X-ray Results for the Titanium Vessel on ACC-013

An explanation of the labeling: The dressed cavity ACC-013 contains the titanium vessel that the manufacturer, Hi-Tech, labeled Vessel #6. Vessel #6 contains the welded 9.5-inch diameter tube that Hi-Tech labeled Tube #9.

Figure 1 – Weld numbers labeled for Vessel #6

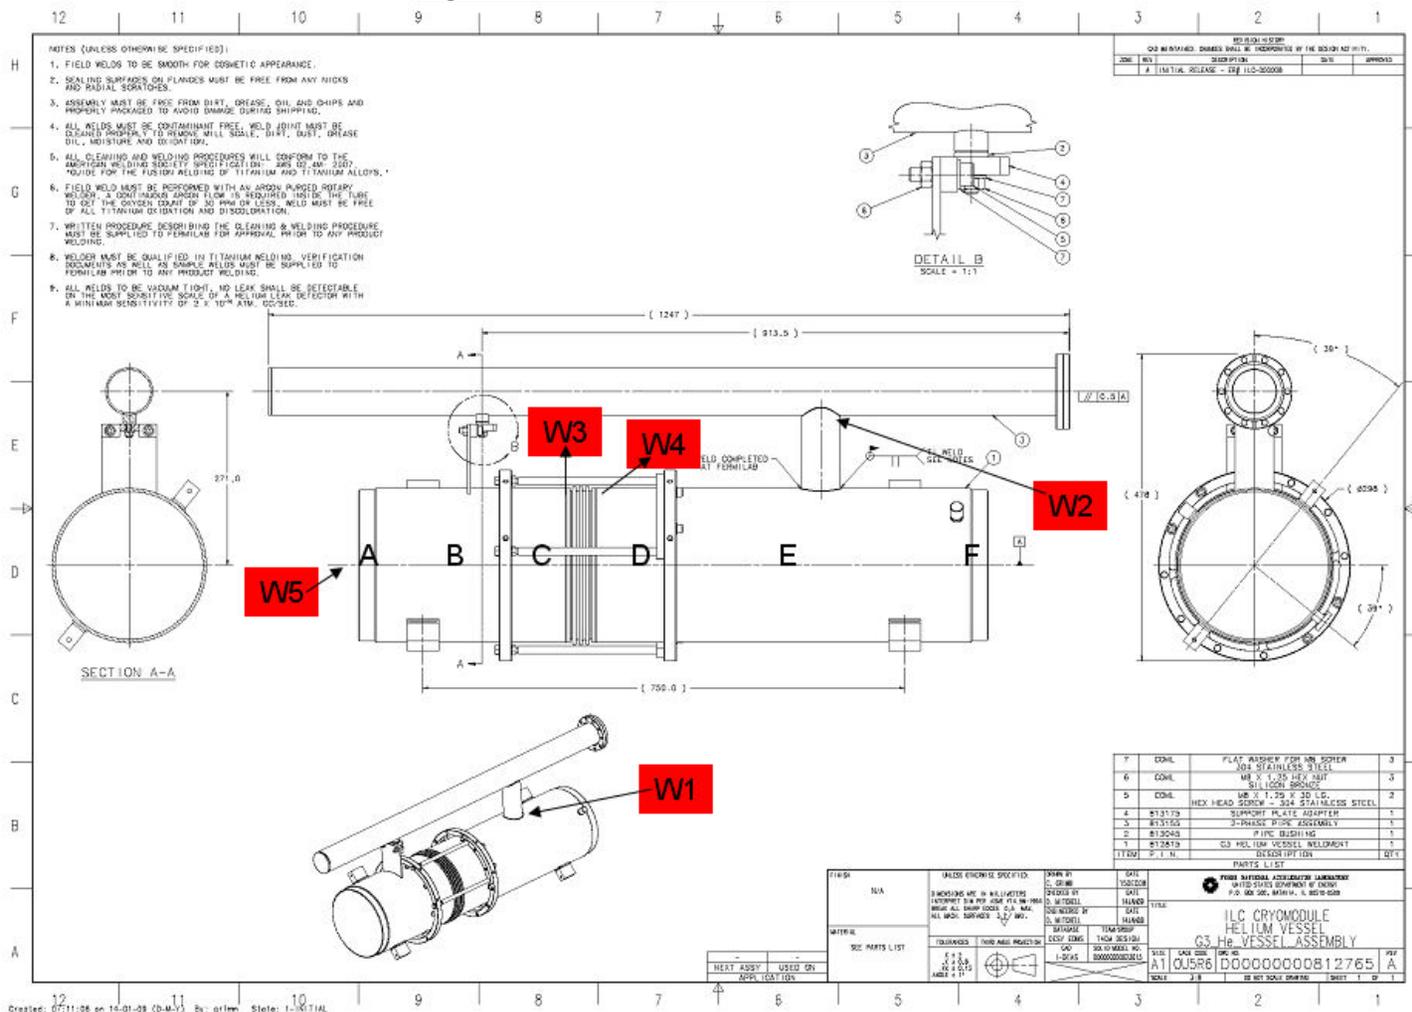
The following reader sheet shows that there are non-conformities in the bellows weld (Weld #3) and in the seam weld (Weld #5). See Figure 1 for weld numbers.

X-RAY SERIAL NUMBER SERIAL #6	Accept	Non-Conforming	Cracks	Shrinkage	Shrink Cavities	Porosity	Gas Holes	Voids	Surface	REMARKS OR OTHER DISCONTINUITIES
WELD #1 A-B	X									
B-C	X									
C-D	X									
D-A	X									
WELD #2 A-B	X									ID SURFACE
B-C	X									
C-D	X									
D-A	X									
WELD #3 A-B	X									
B-C	X		X				X			
C-D	X		X				X			
D-E	X									
E-F	X									
F-G	X									
G-H	X									
H-A	X									
WELD #4 A-B	X									
B-C	X									
C-D	X									
D-E	X									
E-F	X									
F-G	X									
G-H	X									
H-A	X									
WELD #5 A-B	X		X							LACK OF FUSION
B-C	X		X							LACK OF FUSION
C-D	X		X							LACK OF FUSION

Regarding the seam weld on Vessel #6 (Weld #5): When the tube (Tube #9) was first seam welded, it was x-rayed. The following reader sheet shows that weld was acceptable (SN: 9). For this reason, Fermilab accepts this vessel assembly as conforming Code.
